Access Compliance Report

Public Rights-of-Way

(Curb Ramps)

Intersection ID: 52929	Main Street: ENGLISH_OAK_LEAF_CT	Cross Street: GRAY_OAK_LN	Location: NE
ADA ID: F46D129B753E	Ramp Type: Perp	Initial Pass/Fail: Fail	Overall Compliance: No
Severity Score: 8.75			
Codes/Mitigation Info/Possible Solution		Field Measurements/Component Compliance

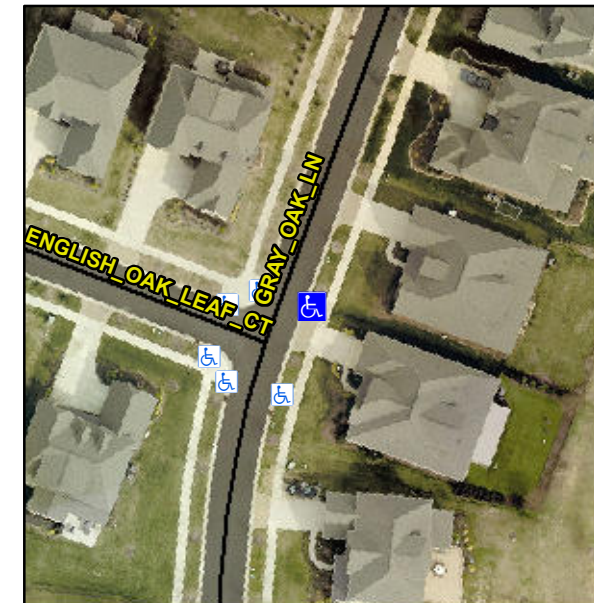
Not Found, R304.5.1

Compliance	Description	Data	Compliance	Description	Data
N/A	Ramp Length (in)	96.0	Yes	Ramp Slope (%)	5.1
No	Ramp Width (in)	47.0	Yes	Ramp XSlope (%)	0.9
N/A	Flare Type LT	N/A	N/A	Flare Type RT	N/A
N/A	Flare Slope LT (%)	N/A	N/A	Flare Slope RT (%)	N/A
N/A	Flare Traversable LT?	N/A	N/A	Flare Traversable RT?	N/A
N/A	Landing Length (in)	N/A	N/A	DWS Provided?	N/A
N/A	Landing Width (in)	N/A	N/A	DWS Contrast?	N/A
N/A	Landing Slope (%)	N/A	N/A	DWS Length (in)	N/A
N/A	Landing X Slope (%)	N/A	N/A	DWS Full Width?	N/A
N/A	Landing Curb? (Y/N)	N/A	N/A	DWS Offset (in)	N/A
N/A	Shared Landing?	N/A			
N/A	Gutter Ponding?	N/A	N/A	Gutter Slope (%)	N/A
N/A	Gutter Lip Ht (in)	N/A	N/A	Gutter X Slope (%)	N/A
N/A	Painted X Walk1?	No	N/A	Painted X Walk2?	N/A
	X Walk 1 Direction	To W		X Walk 2 Direction	N/A
N/A	X Walk 1 Width (in)	N/A	N/A	X Walk 2 Width (in)	N/A
	X Walk 1 Slope (%)	3.9		X Walk 2 Slope (%)	N/A
	X Walk 1 X Slope (%)	2.2		X Walk 2 X Slope (%)	N/A

N/A	Ramp inside XWalk1?	N/A	N/A	Ramp inside XWalk2?	N/A
	Road Slope (%)	N/A	N/A	Clear Space?	N/A
	Road X Slope (%)	N/A	N/A	Clear Space to XWalk (in)	N/A
N/A	Any Obstructions?	N/A	N/A	Storm Grate/Utility Hazard?	N/A
	Obstruction Type			Storm Grate/Utility Type	
		N/A			N/A
			Yes	Surface Condition? (G/P)	Good

Remove & Replace Entire Ramp.
